TECHNICAL SERVICE BULLETIN

NO. 2 A 35

SUBJECT:

Engine Steady Bar

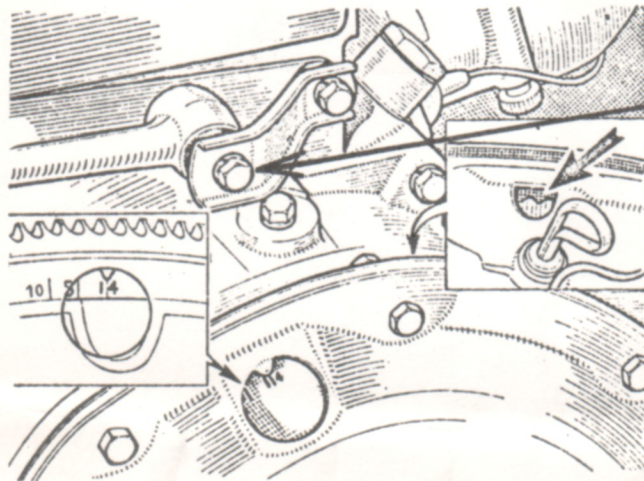
Isolated cases have been reported of the engine steady bar to cylinder block securing bolt working loose and in extreme cases eventually breaking.

Would you please advise all service personnel to check and tighten this bolt if necessary during routine maintenance services.
